**ON-SITE SEWAGE DISPOSAL SYSTEM
TANK REPLACEMENT
HOWARD COUNTY HEALTH DEPARTMENT
BUREAU OF ENVIRONMENTAL HEALTH**

ADDRESS: 14049 Monticello Drive PROPERTY OWNER: Matthew and Catheine Berdini

**14049 MONTICELLO DR.
COOKSVILLE, MD 21723**

SITE PLAN TO
ACCOMPANY PERMIT
APPLICATION

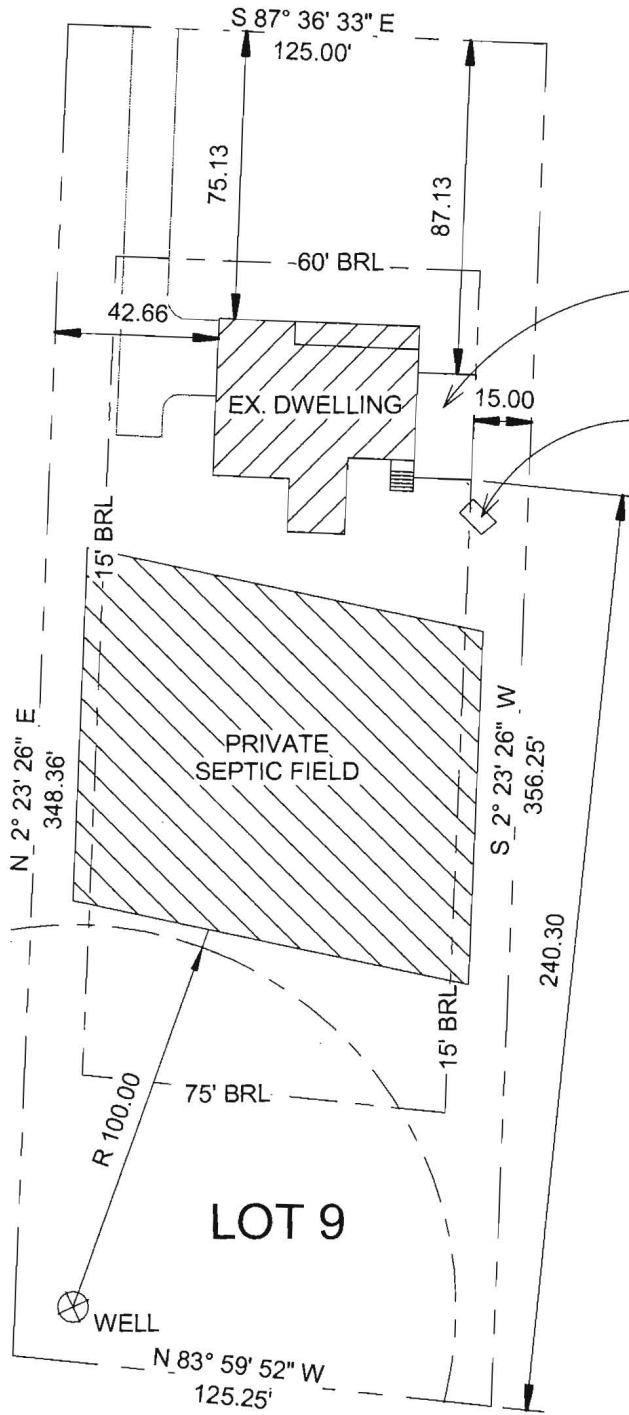
11/12/10 Since bp was already approved, variance was not an option. Told contractor to keep 20' from addition, shoot elevation including max. out of house and in into Dbox, hold 1% 4" S.H.C. to tank, should be OK. Tanks will be located next to top trench. Well when ready see

11/19/10 S.H.C. raised ~10". coming out of new addition. Tanks set >20' from addition. Plumbing held 1% to Dbox. OK to build CRH
